Planning Commission Meeting 3468 North Fulton Avenue Hapeville, Georgia 30354

AGENDA

PLANNER'S REPORT

RE: Site Plan Review – 3472 Rainey Avenue

DATE DUTHSIDF #18 ATLANTA ST. MCDONOUGH, GA 30253 SURVEYING & PLANNING Phone: (770) 320-8009 LSF000831 Fax: (770) 320-8098 RETRACEMENT SURVEY AND CONCEPTUAL PLAN FOR: USONIAN HOMES, LLC CITY OF HAPEVILLE Land Lot 98 14TH Dist. FULTON County, GA Drawn By: AMM SR. Scale: 1"=40' Dwa No: 2-190105R

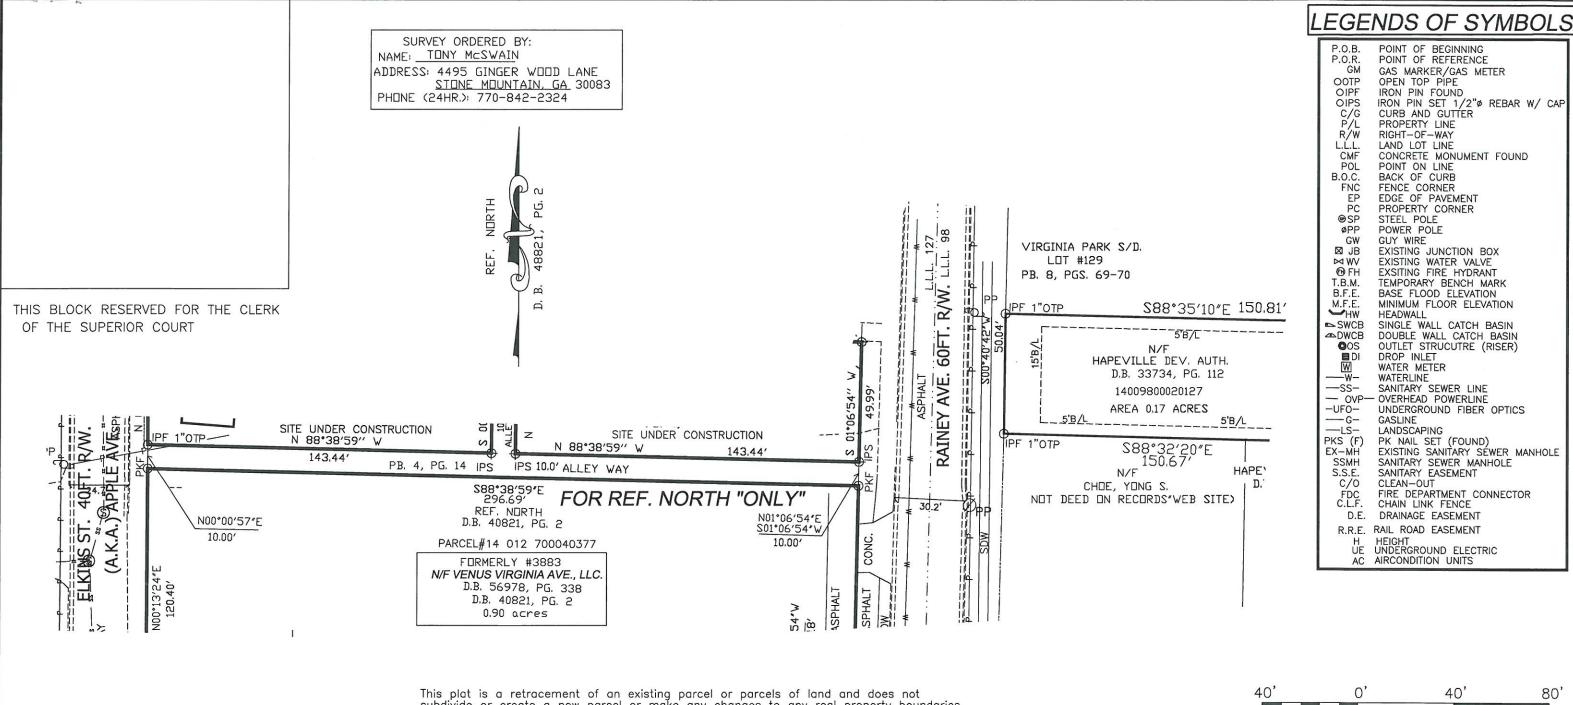
- The plans show the location of the driveway, curb cuts, sidewalk, and a walkway extending from the sidewalk to the building entrance. However, only the width of the driveway is provided. <u>The Applicant</u> <u>should provide the general design cross section characteristics for the driveway, curb cuts, and sidewalk.</u>

- d. Existing and proposed grades at an interval of five feet or less.
- Existing and proposed grades are shown, but at undefined intervals. The Applicant should provide labeled existing and proposed grades at an interval of five feet or less.

- The landscape plan proposes four crape myrtle trees, 18 shrubs, and a Bermuda grass ground cover.
- One street tree is required per 40' of road frontage. <u>The Applicant should include a minimum of one street tree planted in the sidewalk's landscape area.</u>

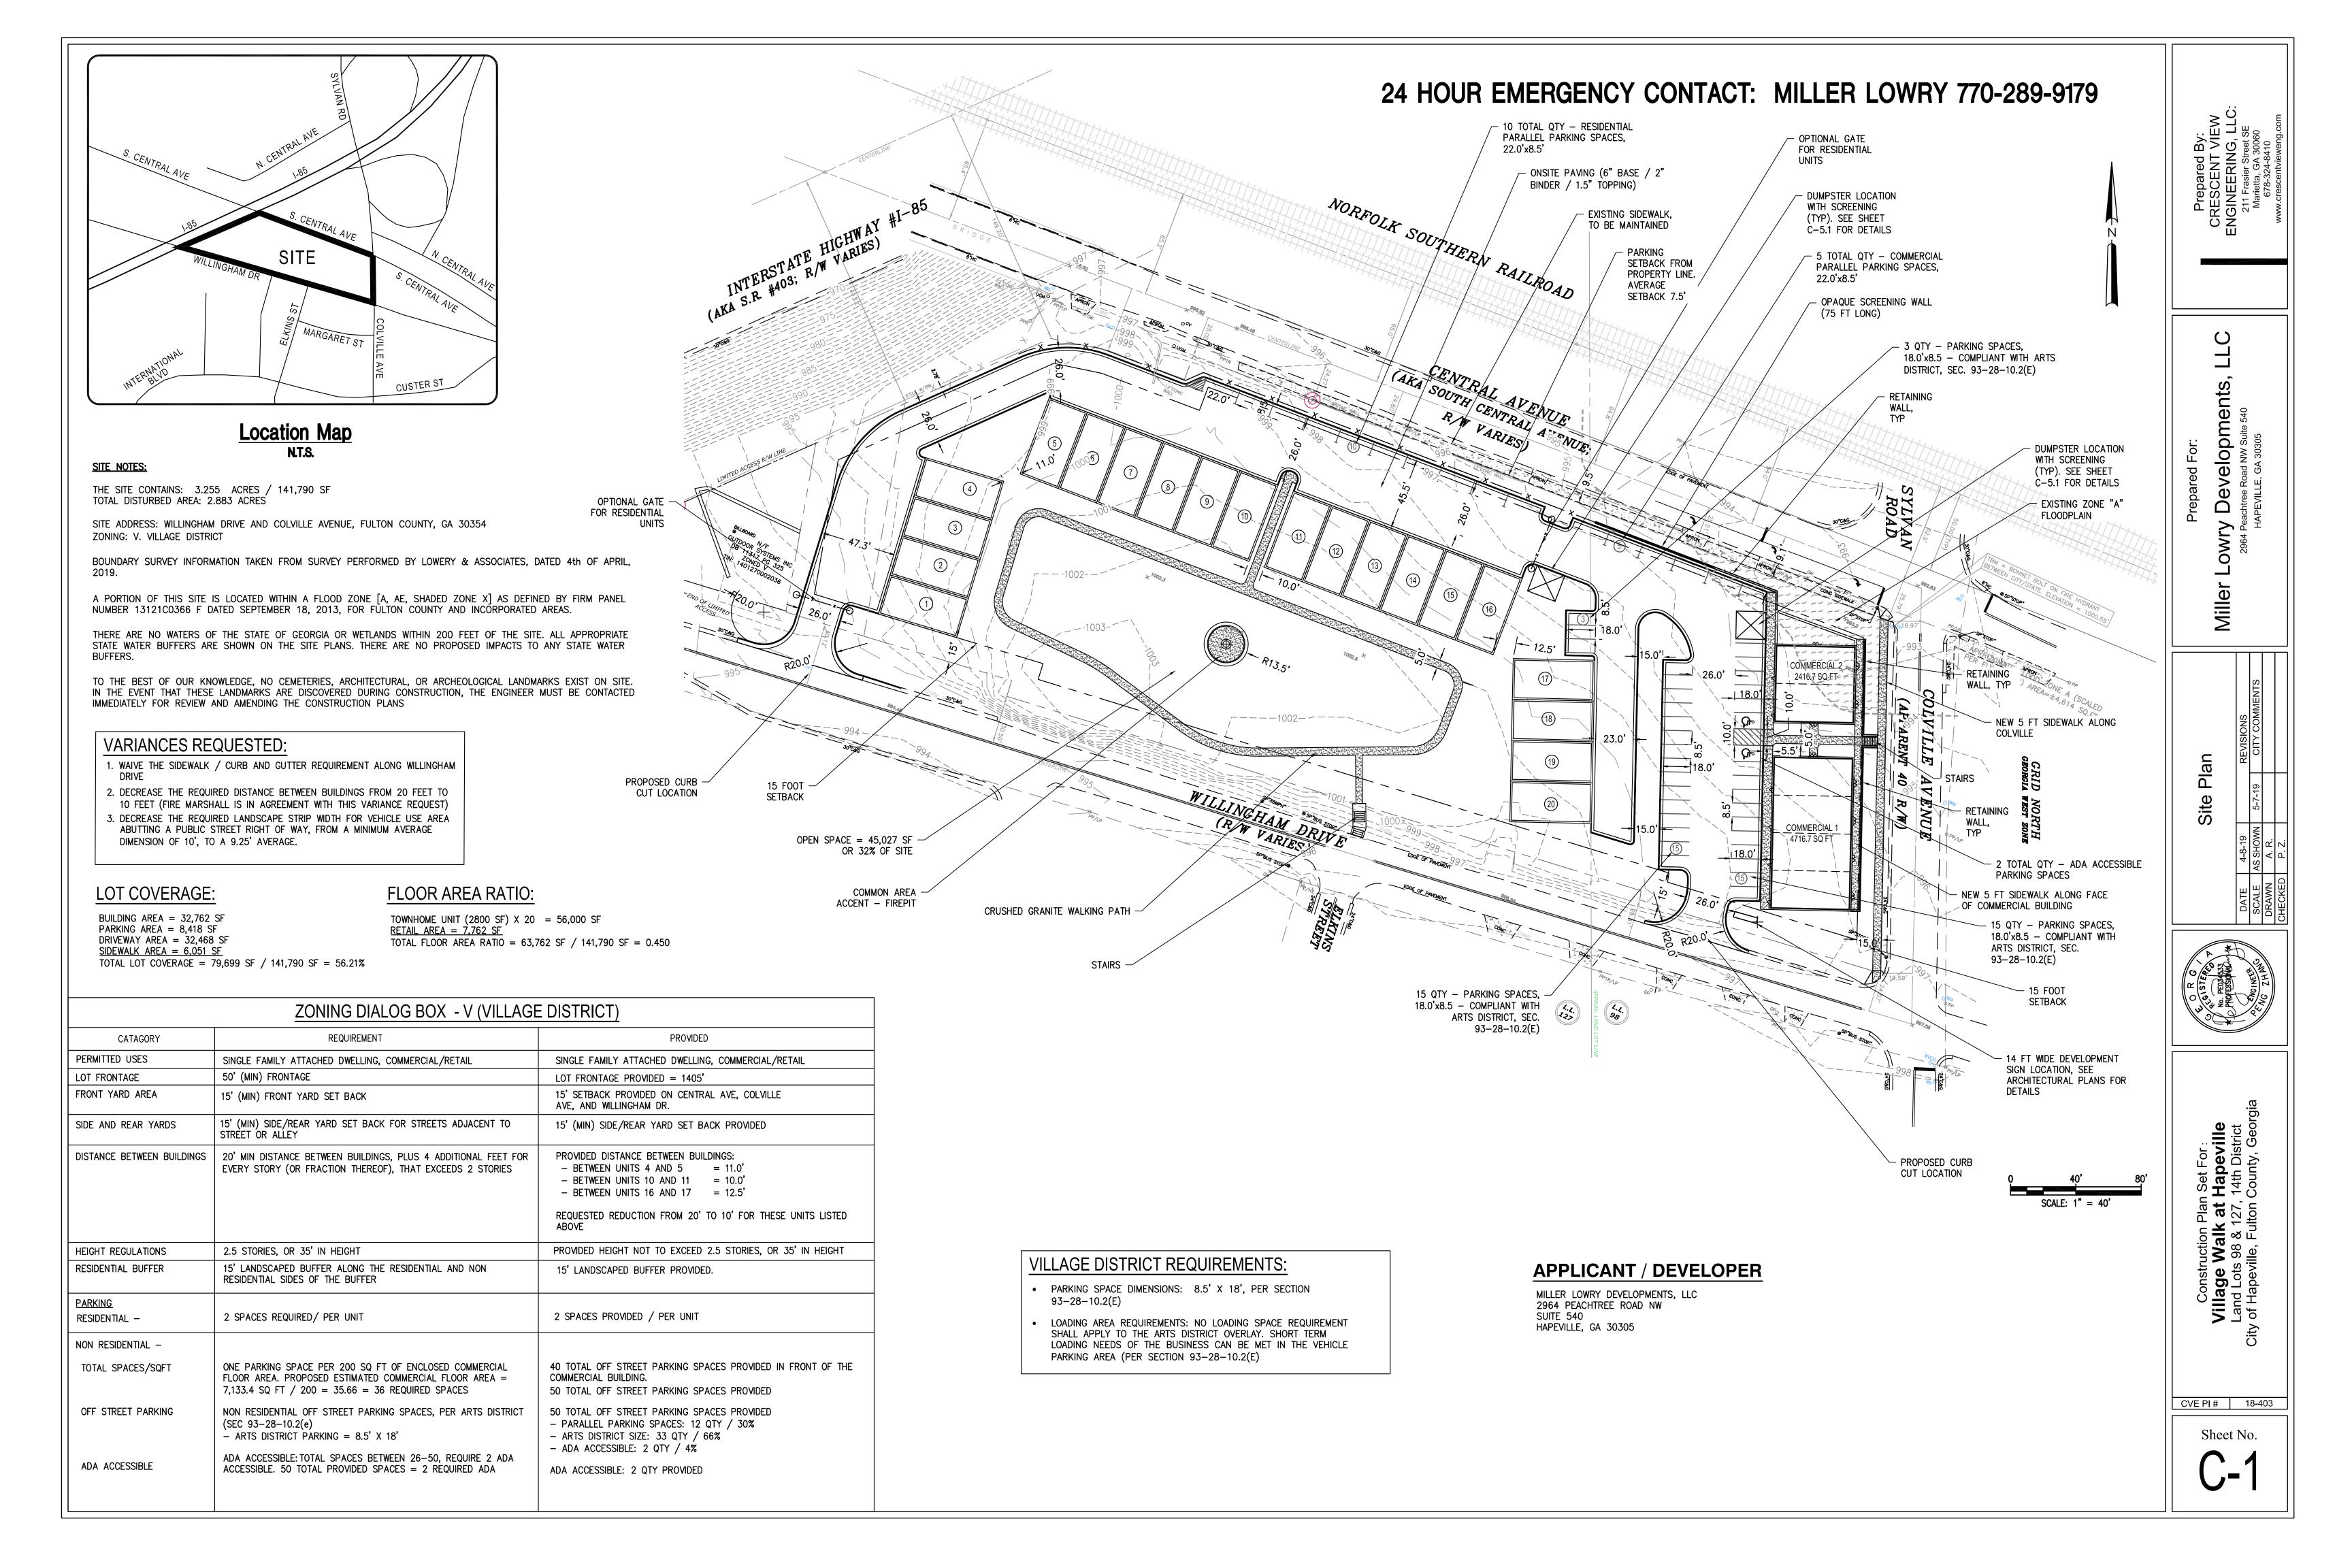
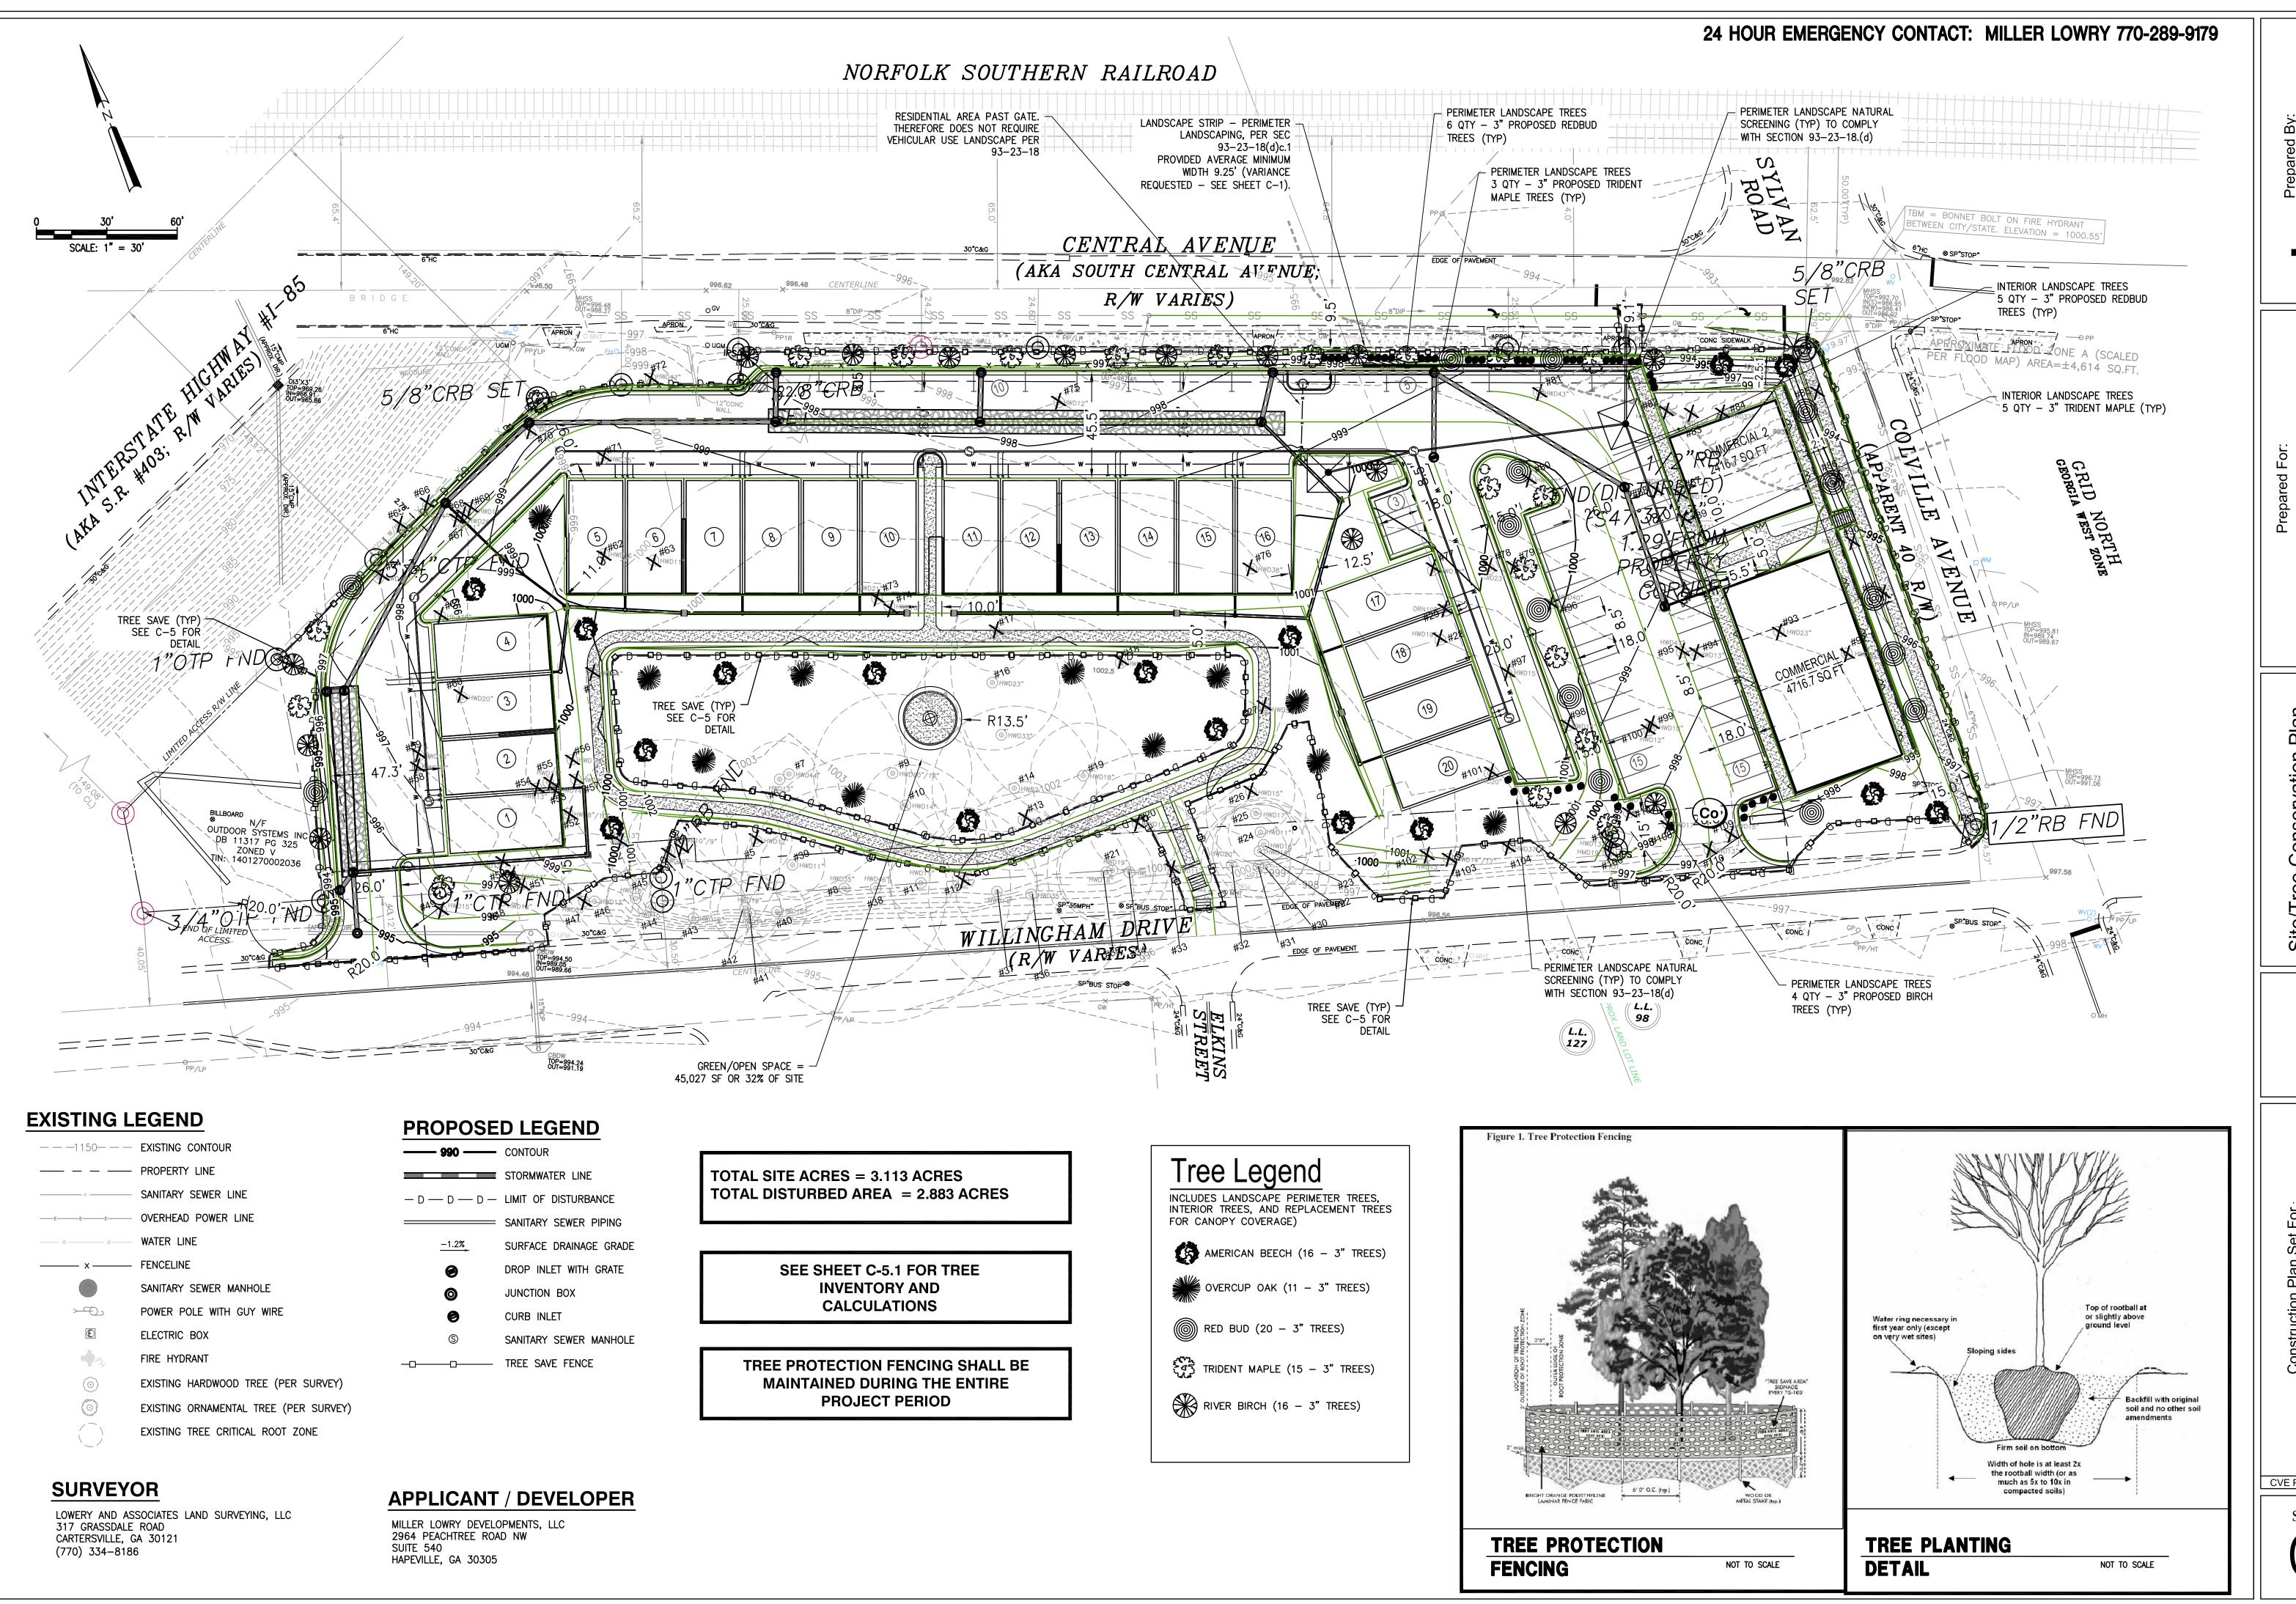
- 55. The site plan does not consistently include a 15' landscaped buffer between residential and non residential uses, including along South Central Ave.
- CVE Response: See Newly Provided Landscaping Plan as part of the submission 56. Parking along Colville is within 5' of the property line, but designed as on-street parking. This would require a variance.
 - CVE Response: See site plan as the parking is now designated as off-street parking.
- 57. The Fire Marshall has concerns with maneuvering areas and requires a 26' wide land through the project. This will impact the location of the buildings.
 - CVE Response: See site and grading plan for 26' wide drive isle.
- 58. Size and location of off-street loading spaces is not provided.

CVE Response: one 15 foot by 60 foot loading space is located along Central Avenue north of the commercial 2 building and the dumpster.
